UNITED STATES  
NUCLEAR REGULATORY COMMISSION  
REGION III  
799 ROOSEVELT ROAD  
GLEN ELLYN, ILLINOIS 60137

IE Circular No. 79-02

FAILURE OF 120 VOLT VITAL AC POWER SUPPLIES

FIGURE 1  
 SINGLE LINE DIAGRAM - 120 VAC

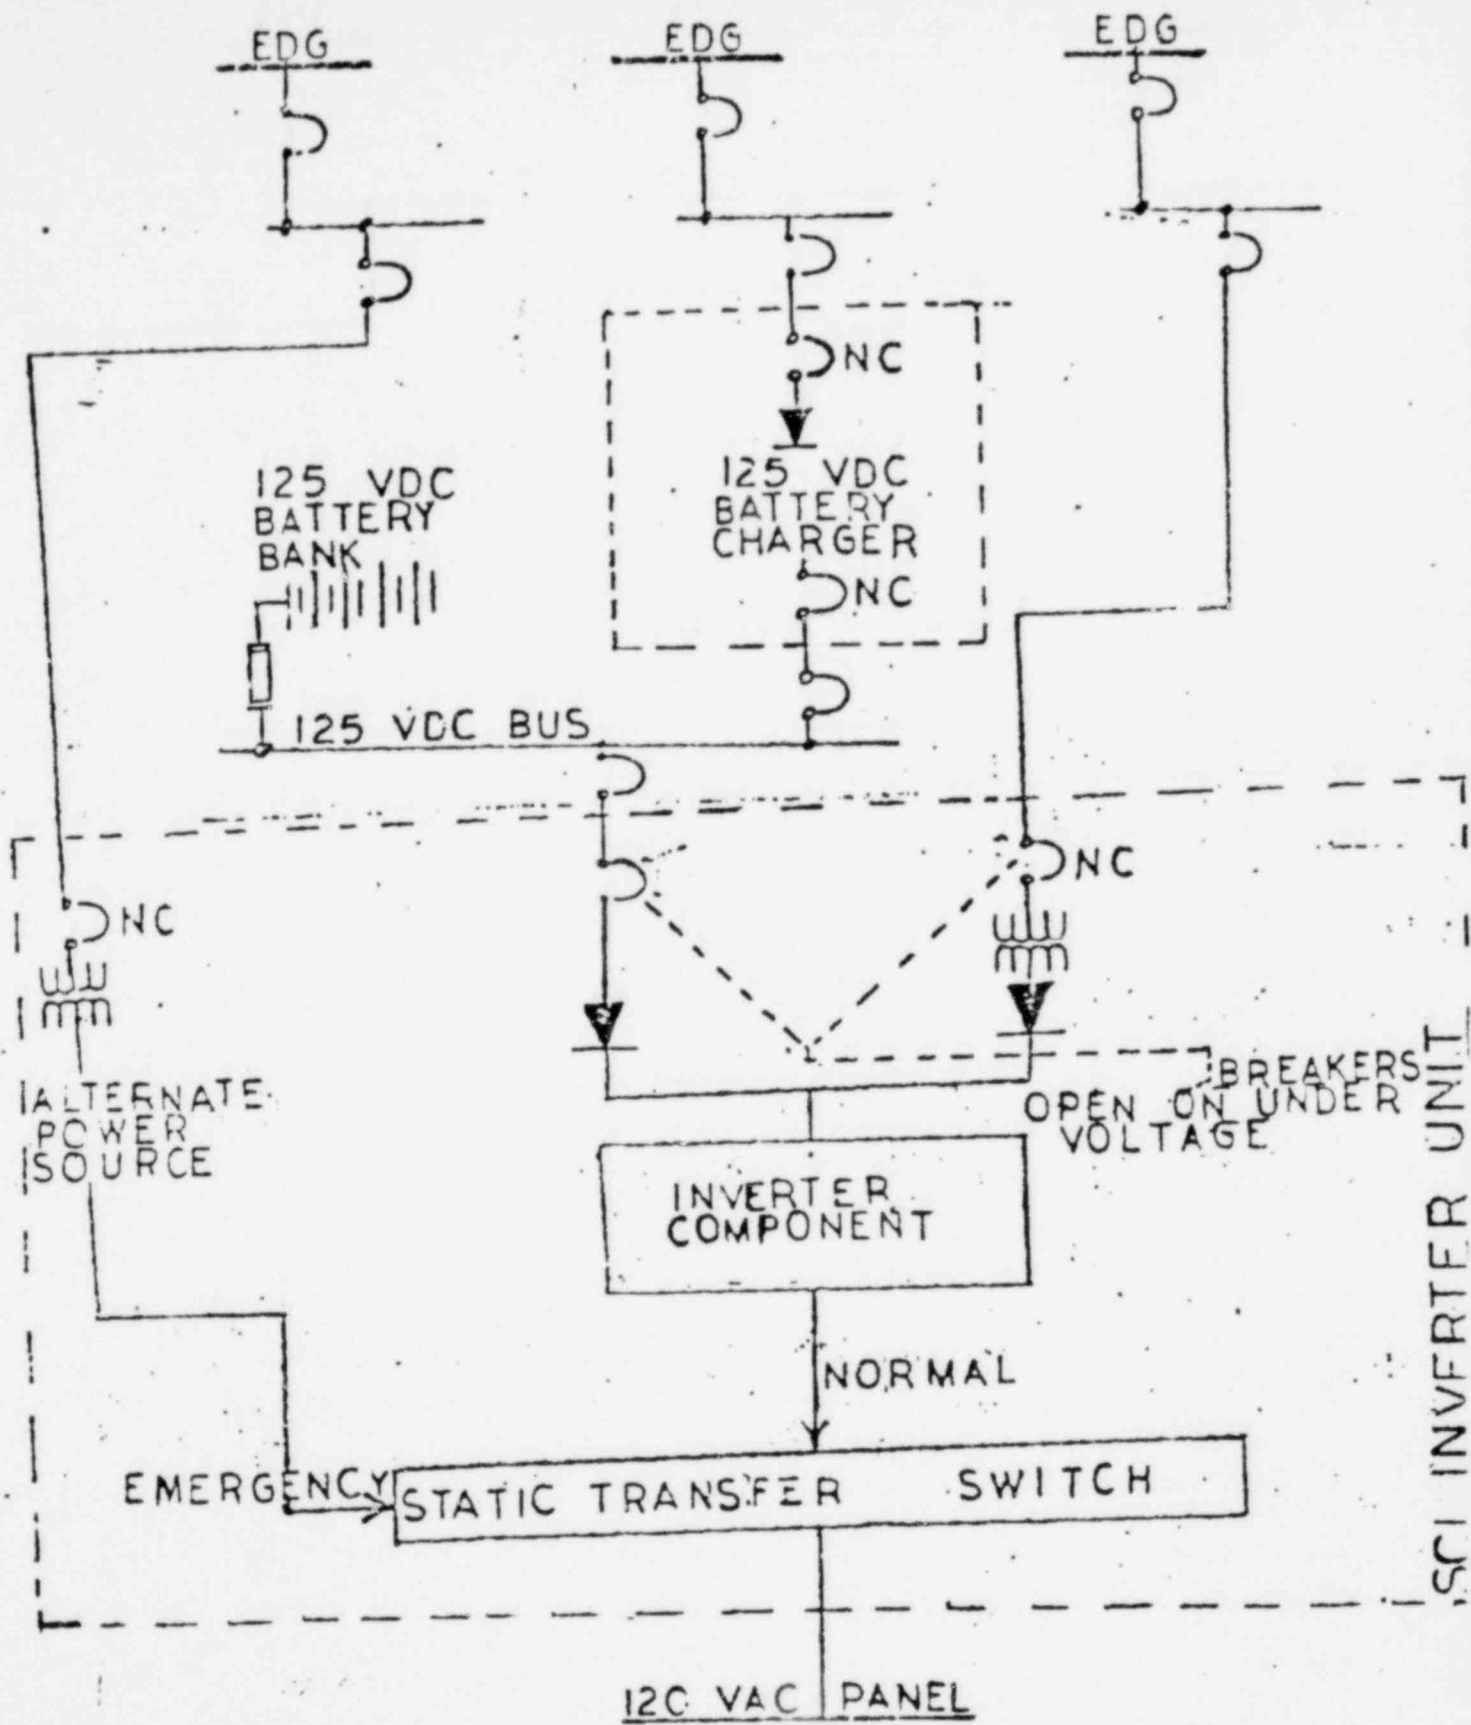
On September 16, 1978, Arkansas Nuclear One - Unit 2 while in hot functional testing preceeding initial criticality, suffered a degradation of both of the independent off-site power sources. This produced an undervoltage condition on the Engineering Safety Features (ESF) Buses and caused an inadvertent ESF actuation. The licensee determined that the ESF actuation occurred on a loss of at least two of the uninterruptable 120 volt vital AC power sources. Immediate investigation revealed that all four of the Solidstate Controls, Inc., (SCI) inverter static switches had automatically transferred to the alternate power supply (the 120 volt AC being supplied by transformers directly off the ESF buses rather than from the inverter output.) Figure 1 (attached) shows the functional interconnection of the 120 volt AC power supply system.

A single conclusive cause of the undesired SCI inverter static switch transfer could not be identified. However, the following problems were discovered during subsequent investigation.

- (a) The SCI inverters have circuitry to monitor the incoming DC voltage level which, on sensing a low voltage (nominally 104 DC volts for these inverters) will trip both input breakers to the inverter component after an adjustable time delay.

The setting of these time delay relays were not verified during either preoperational testing or subsequent maintenance. The time delay is necessary in order to accommodate transient loading conditions which may be encountered.

- (b) On one SCI inverter, a DC fuse within the inverter component was found blown. The vendor indicated that this fuse will blow due to an excessive DC voltage to the inverter component caused by a transient on the 480 AC input. The licensee has subsequently reset the taps on the 480V to 120V three-phase AC input transformer to limit the DC voltage to the inverter to less than the nameplate maximum rating in the event of a high AC input voltage transient.

- (c) The SCI inverter static switch is designed to transfer to an alternate source on inverter output overcurrent or undervoltage. Initially, these trips were set at 125 percent overcurrent and 80 percent undervoltage. An explanation for the transfer of two of the inverter static switches is that during one of the transfers of site loads, the instantaneous inductive load caused these trip set points to be exceeded. The licensee has subsequently adjusted the transfer sensing circuitry to higher overcurrent and lower undervoltage trip settings to assure that the inverter will maintain load over the widest possible range of voltage and current. (Note that in this case, once the SCI inverter transfers to the alternate source, it will not automatically transfer back to normal source.)

1. Determine whether or not time delay circuitry is used in your inverter units. If so, have they been adjusted to the appropriate set point as required by equipment and the integrated system designs?

2. Determine if the AC input voltage and transformer tap settings are optimized to prevent exceeding the inverter component name-plate maximum rated DC input voltage in the event of a high AC input voltage transient.

3. If an alternate 120 volt source is used in your design, determine if the protection transfer circuitry of the inverter has been optimized within design limits to ensure maximum possible availability of the inverter system during transient loading conditions. An operating history of inexplicable transfers may be indicative of the above.

4. Determine if the administrative controls employed by your facility ensures operability of safety systems after its subcomponents (e.g., time delay relays, switches, etc.) have been subjected to maintenance or testing.
